Certificate of Appropriateness

1507 N. MARSHALL ST. Graham Row

PTS ID 114629 COA: porch masonry repairs

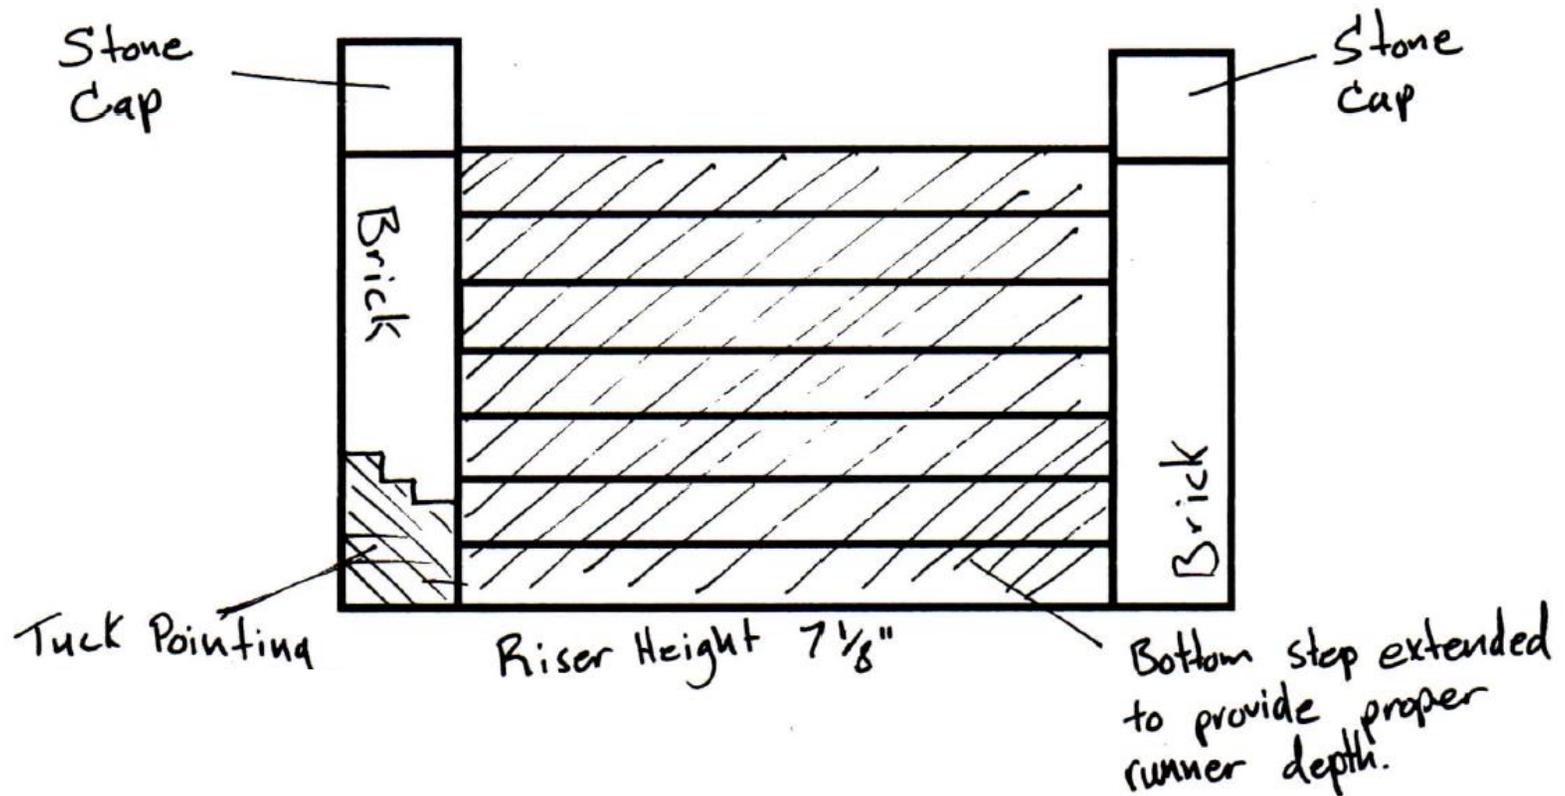
Stair condition detail. Note deterioration at left/south

1. 7 Step, + 1 from existing.
2. Areas of work shaded.
